WAKA KOTAHI STAKEHOLDER WORKSHOP

Recreational user group suggestions for Mackays
Crossing – Thursday 3 December 2020

Existing shared path and SH1 walking and cycling options

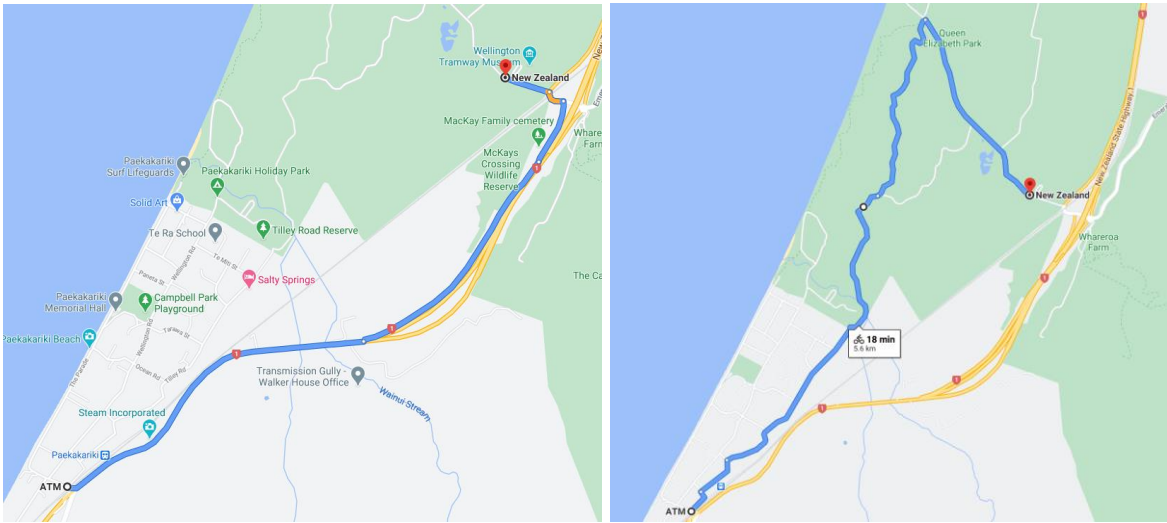
Some comments were raised regarding the relative distances between using SH1 and the local road to reach Mackays Crossing, as opposed to using the shared path through QE Park via Tilley Rd.

The comparative distance depends on where people are starting from. The route from Paekākāriki town centre via SH1 is approximately 3.8km, while the length of the route of the shared path is approximately 5.6km. Moving the start point to the northern end of Paekākāriki (Tilley Road) reduces the distance of the shared path route to 4.7km and increases the SH1 route to approximately 4.9km.
